**PALM BEACH COUNTY
SOLID WASTE AUTHORITY**

Re: Response to July 17, 1985 Letter
Application for Power Plant Siting Certification
Resource Recovery Facility
Palm Beach County Solid Waste Authority

RESPONSE TO FLORIDA DEPARTMENT OF ENVIRONMENTAL REGULATION

Letter Dated July 17, 1985

FIGURE 29-1

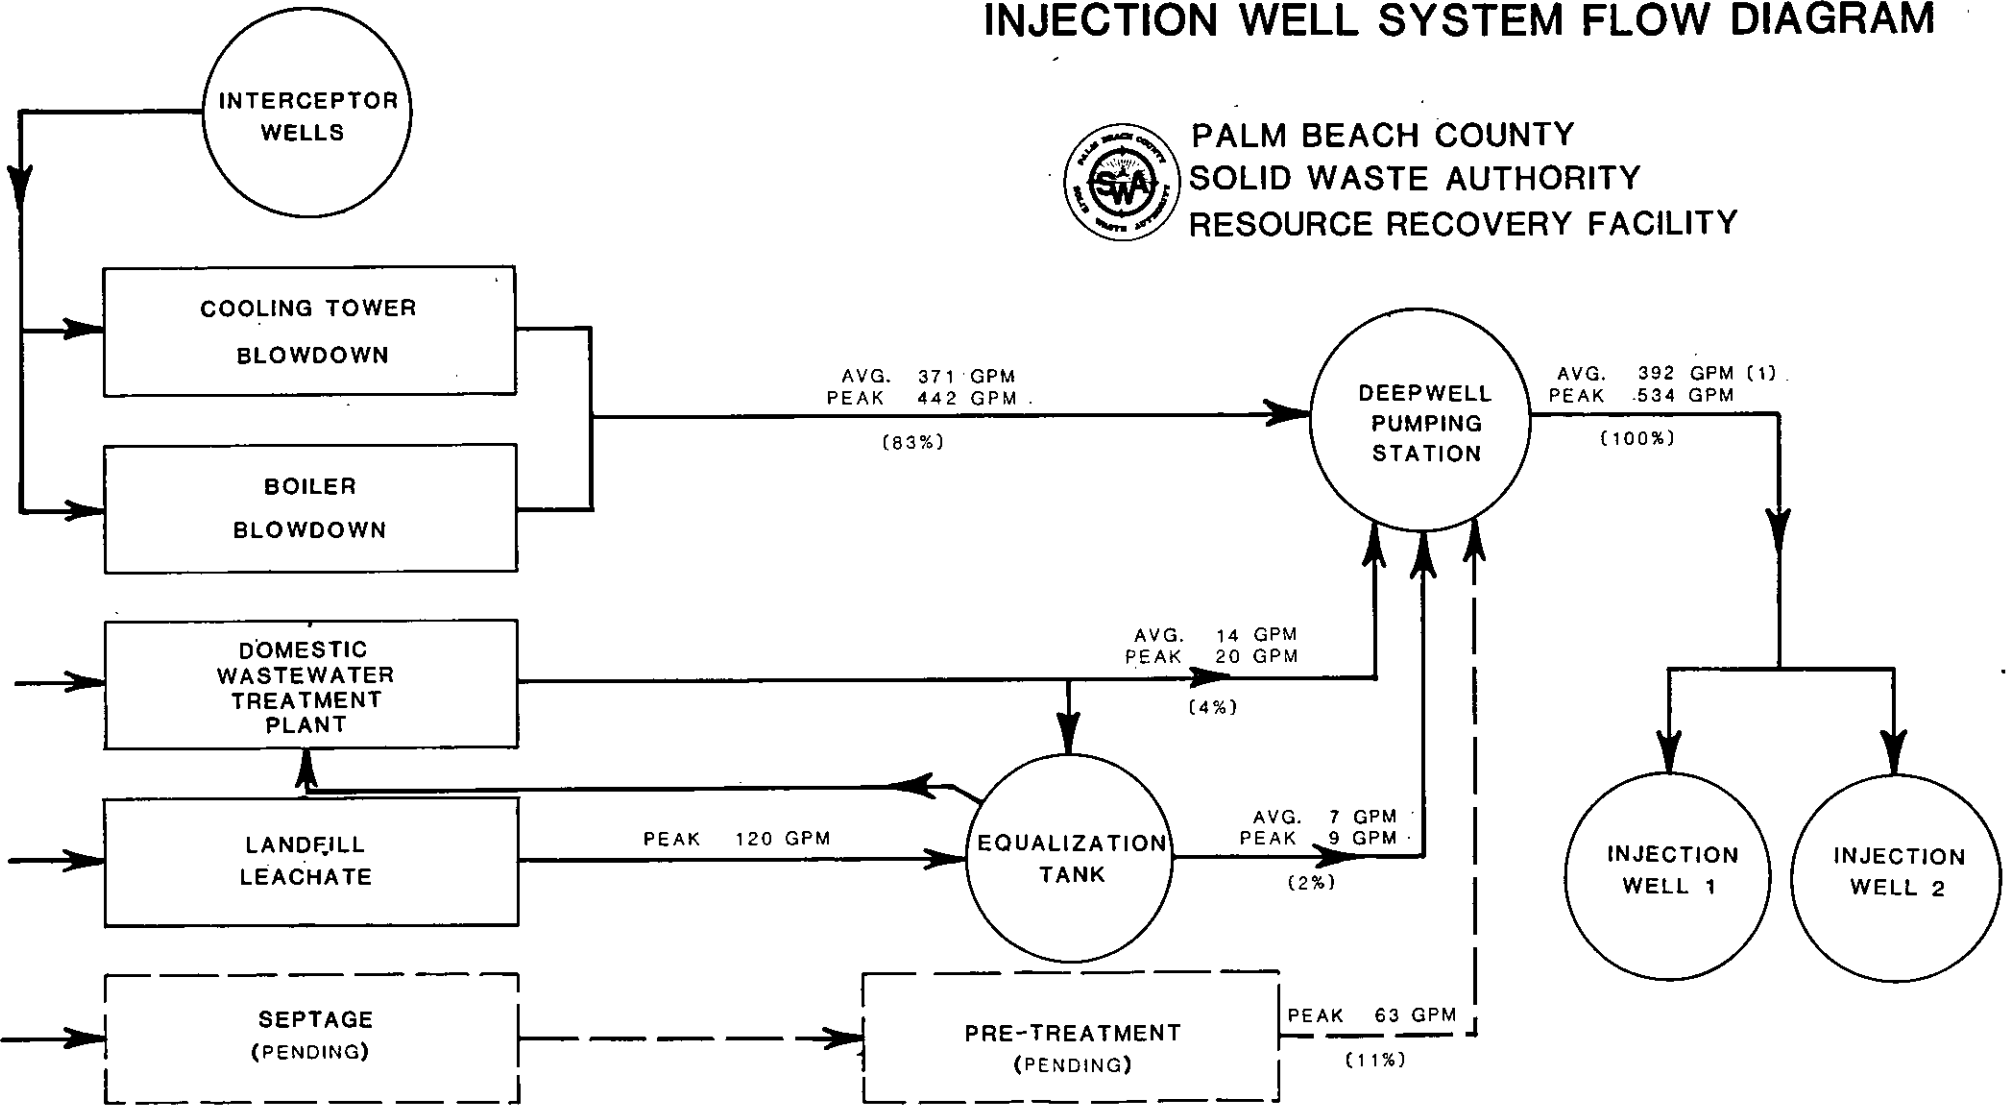
ITEM 19: An analysis of the compatability of the five waste streams which are to be injected must be made. This study should include analyses of the compatability of the waste streams with each other as well as with the formation materials, formation fluids and well construction materials.

SWA RESPONSE NO. 29: The waste streams which will be combined for injection into the "Boulder Zone" are: 1) Resource Recovery Plant Blowdown from boilers, cooling towers and demineralizers; 2) Domestic wastewater treatment plant effluent and; 3) Leachate. The characteristics of the Resource Recovery Plant effluent has been described in Chapter 3 of the Application and Table 3.5-2, Characteristics of Blowdown Mixture, has been included in this response. The characteristics of the effluent from the domestic wastewater treatment plant are representative of values found in effluents in South Florida. The characteristics of the leachate were discussed in Chapter 3 and Appendix 10.7.

An analysis of the combined waste streams is shown on the accompanying table, and as discussed above, representative values have been used. As discussed in the Application, once the monitoring programs are started, actual data on the waste streams can be utilized to conduct a more conclusive analysis. A flow diagram of the waste streams which will be combined is also included in this response.
